## **GENERAL APPLICATION**

November 16, 2017

#### Re: Cumberland Farms – SR 84 &

The following is a response to staff comments. Below are the comments along with our responses in bold:

SHEET NUMBER:

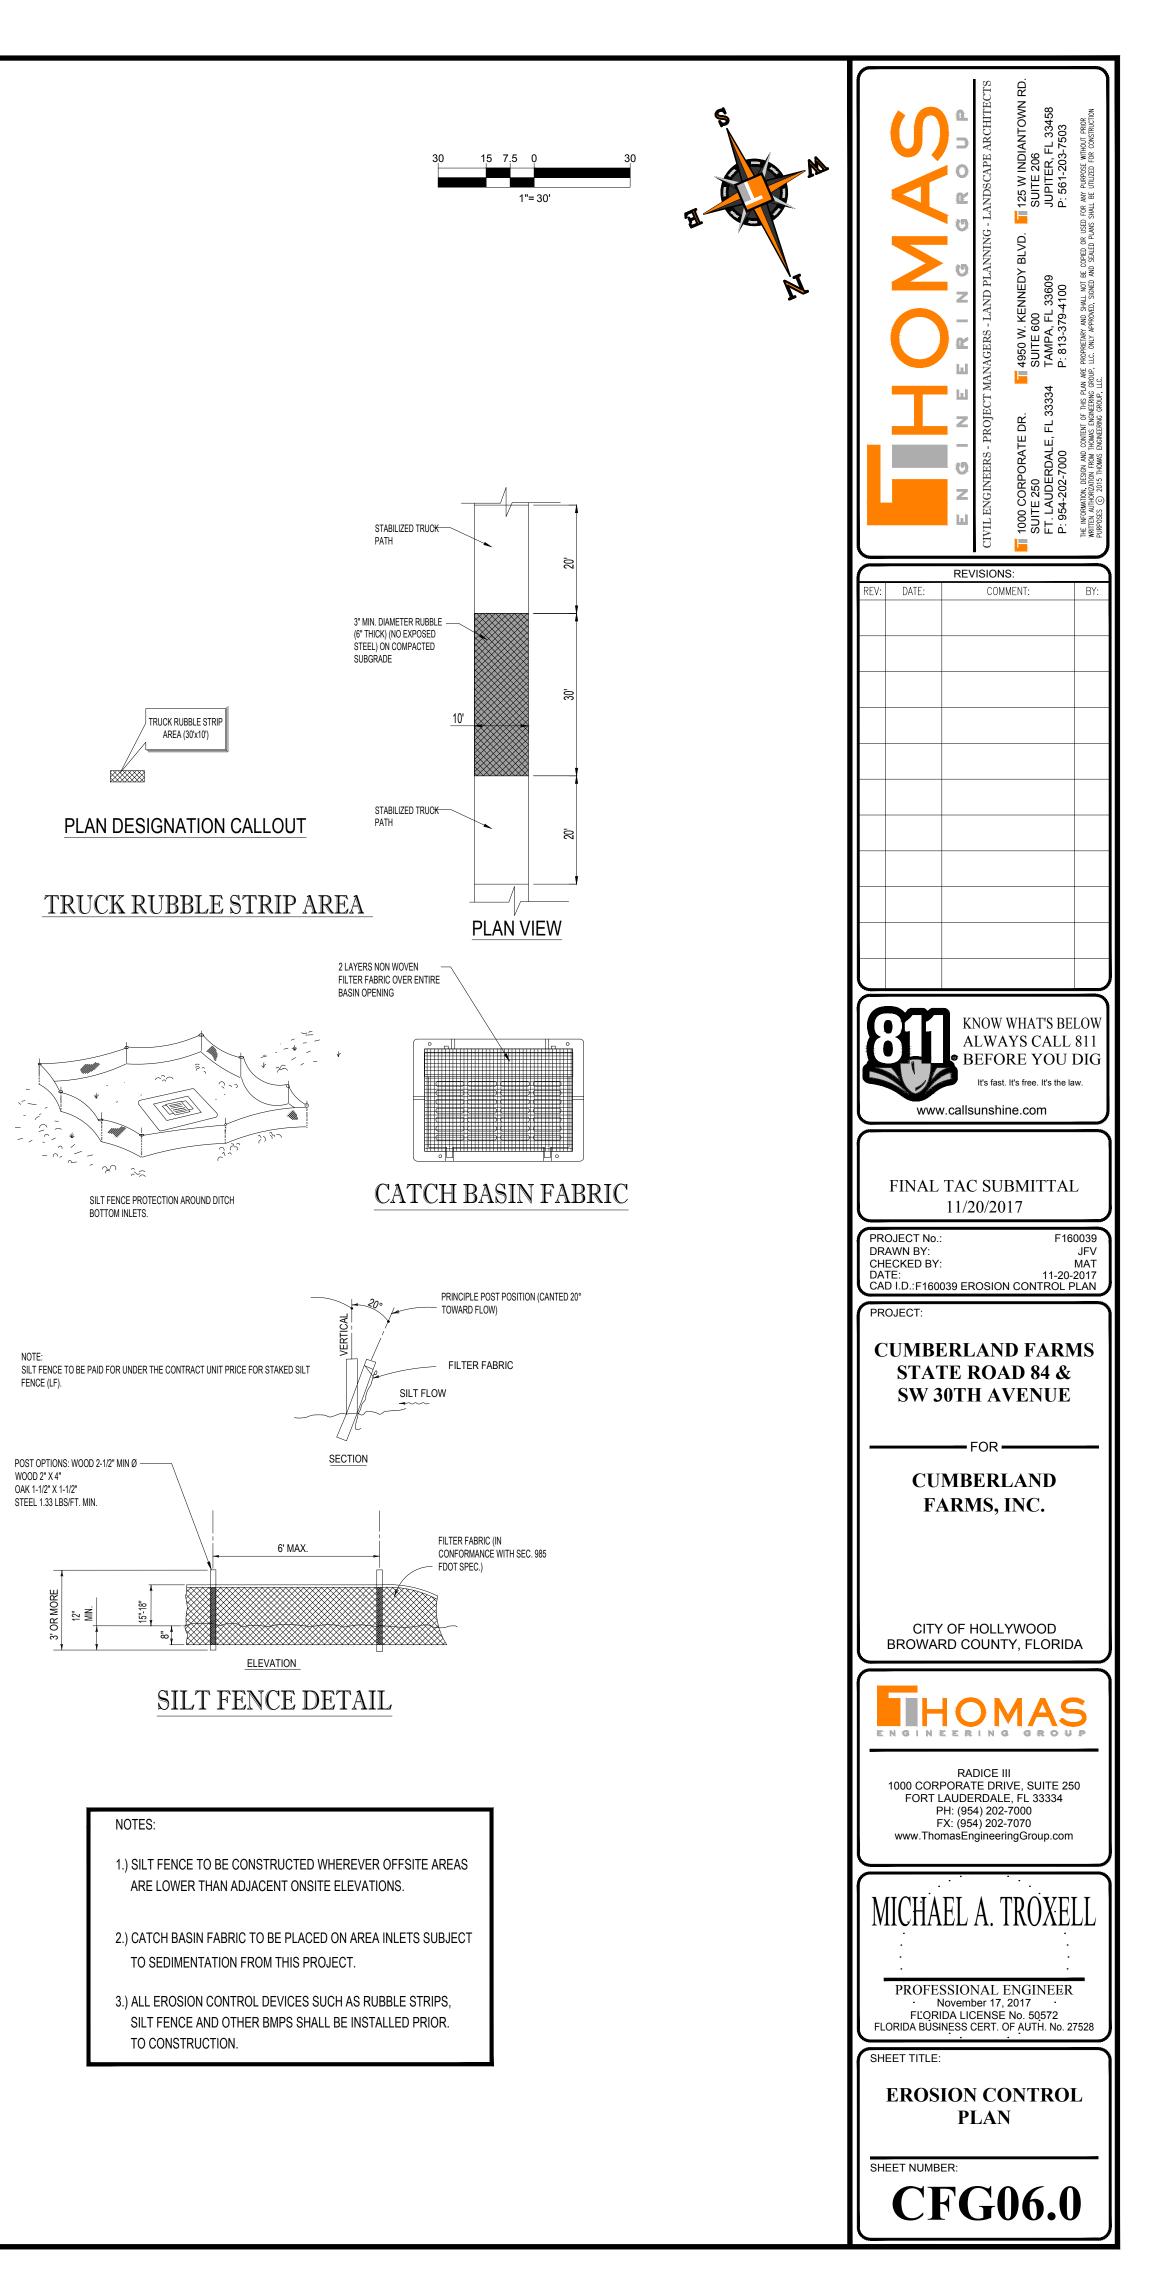
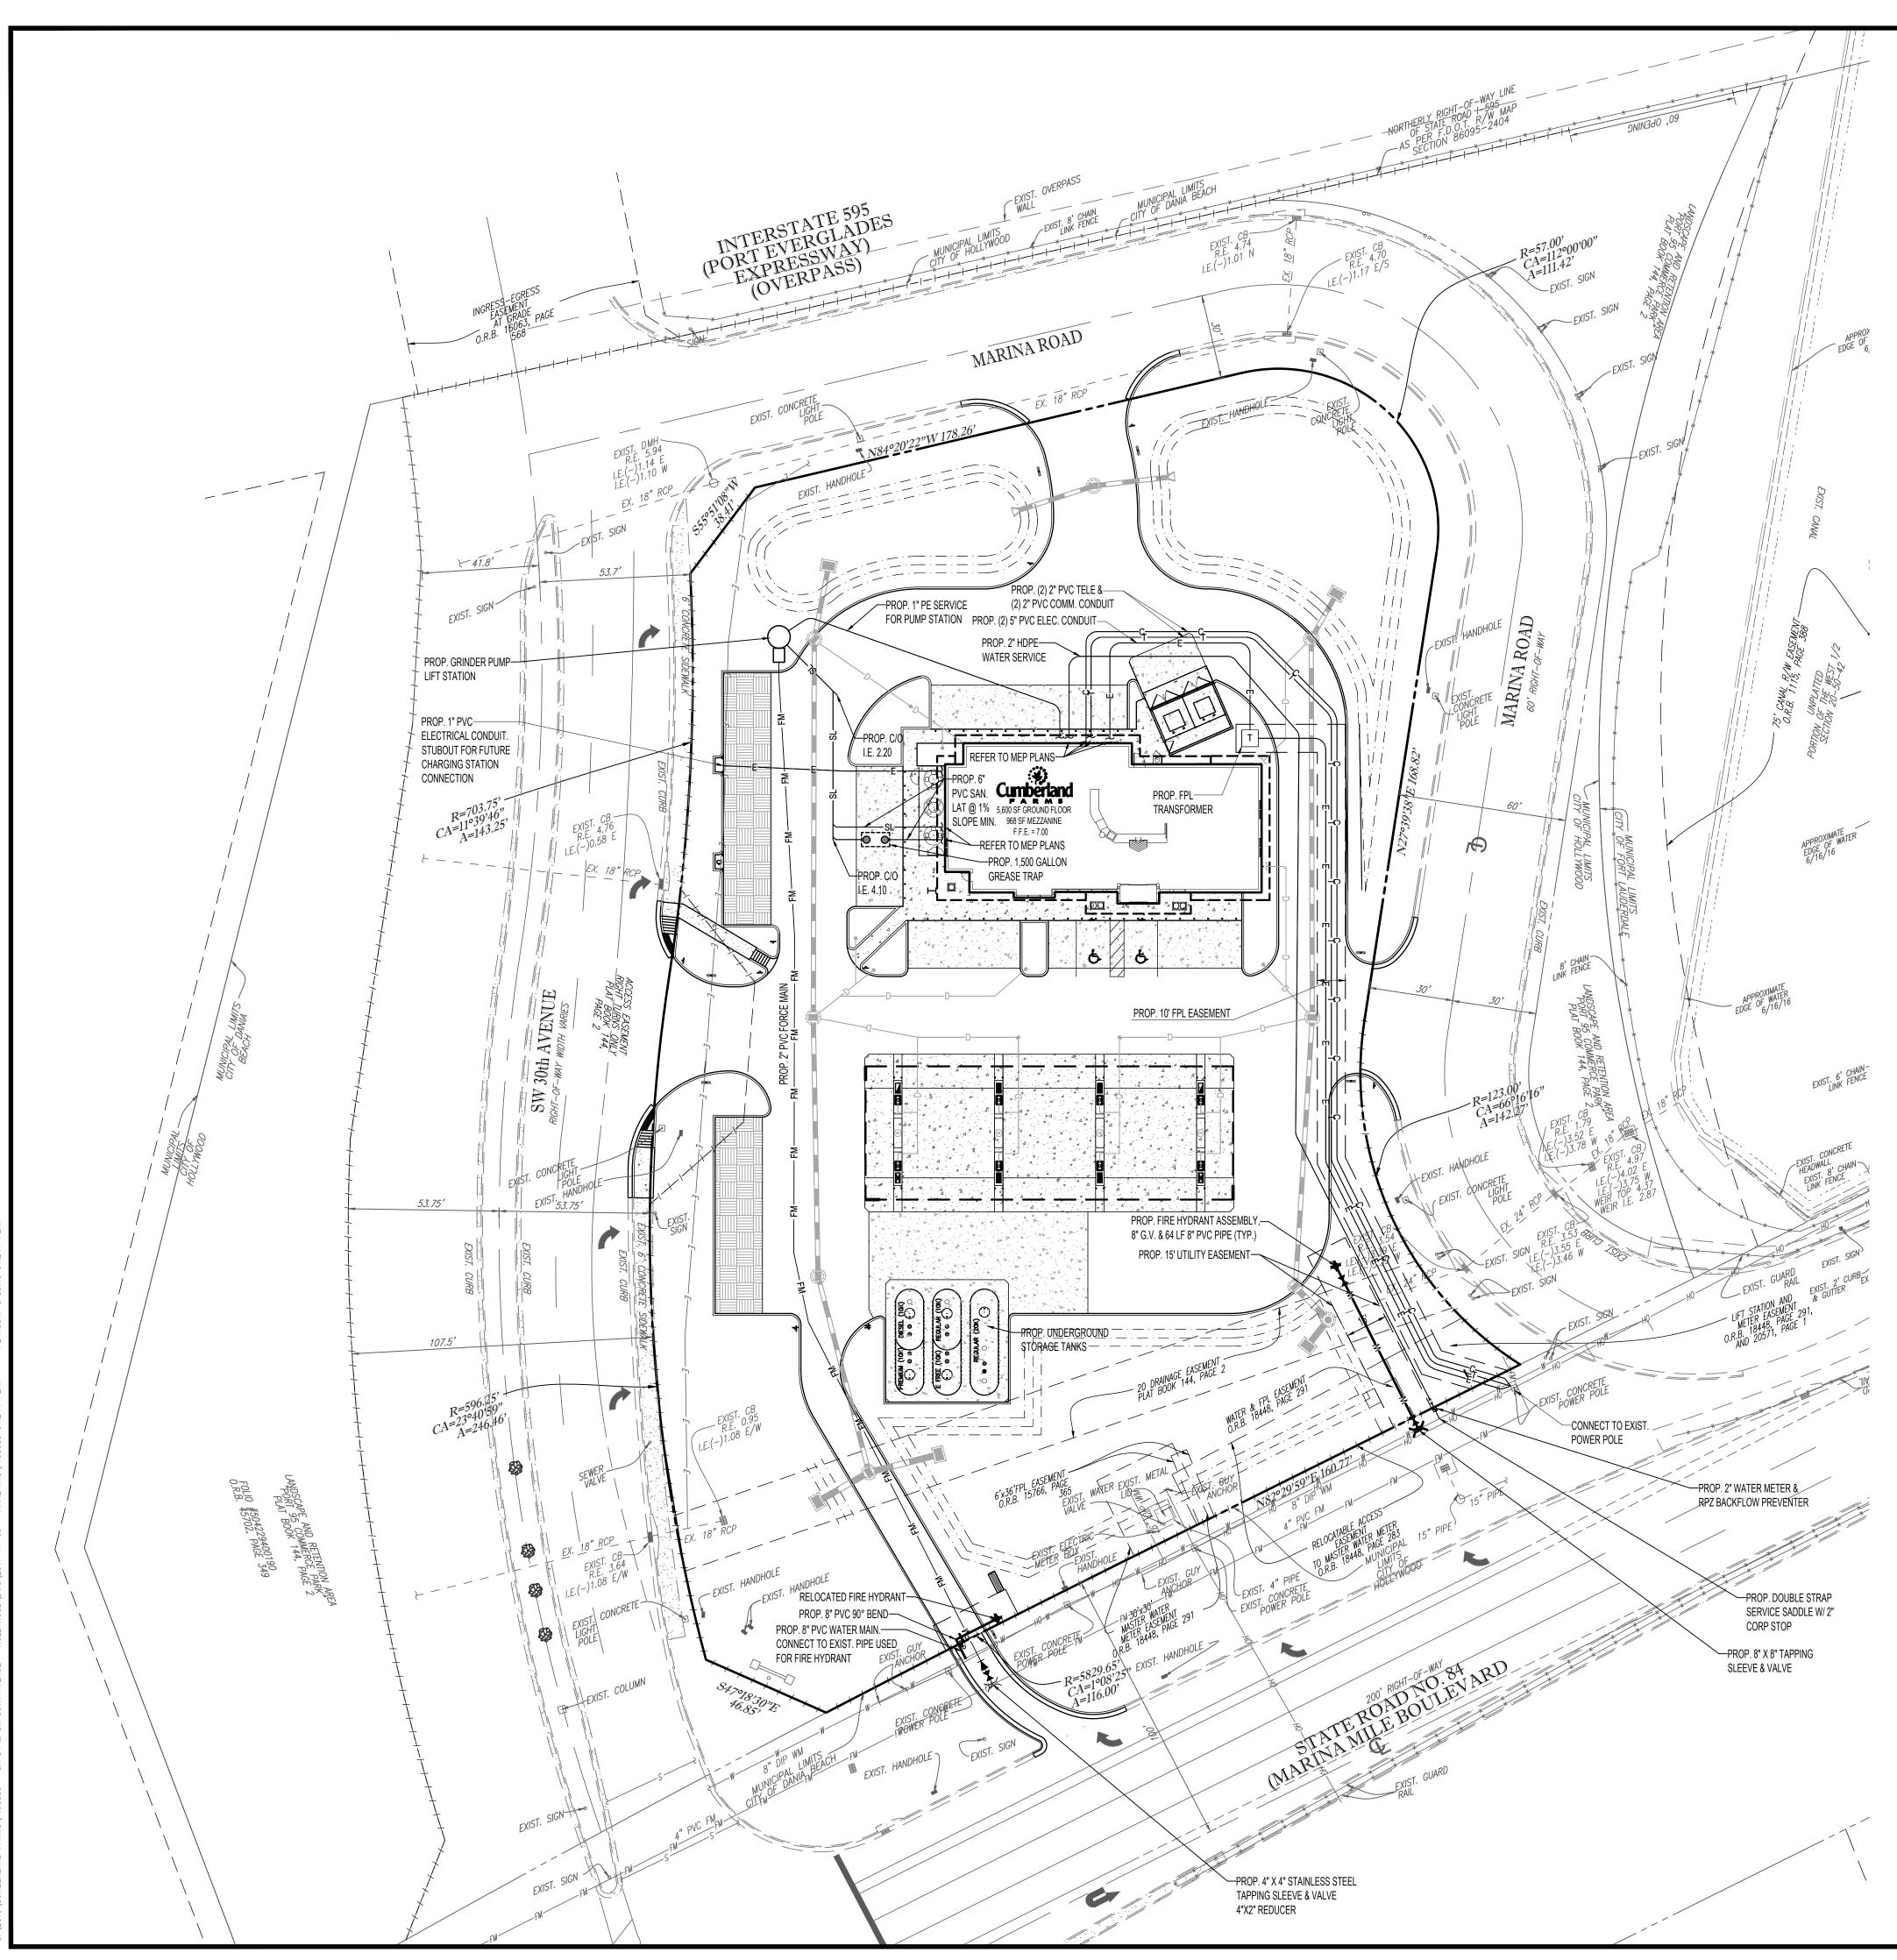
1. Provide Water, Sewer and Drainage plans for review.

**Response:** Water, sewer, and drainage plans have been provided. Refer to sheets CFG5.0 and CFG07.0. A water-sewer availability letter from Broward County Water Wastewater services has been provided.
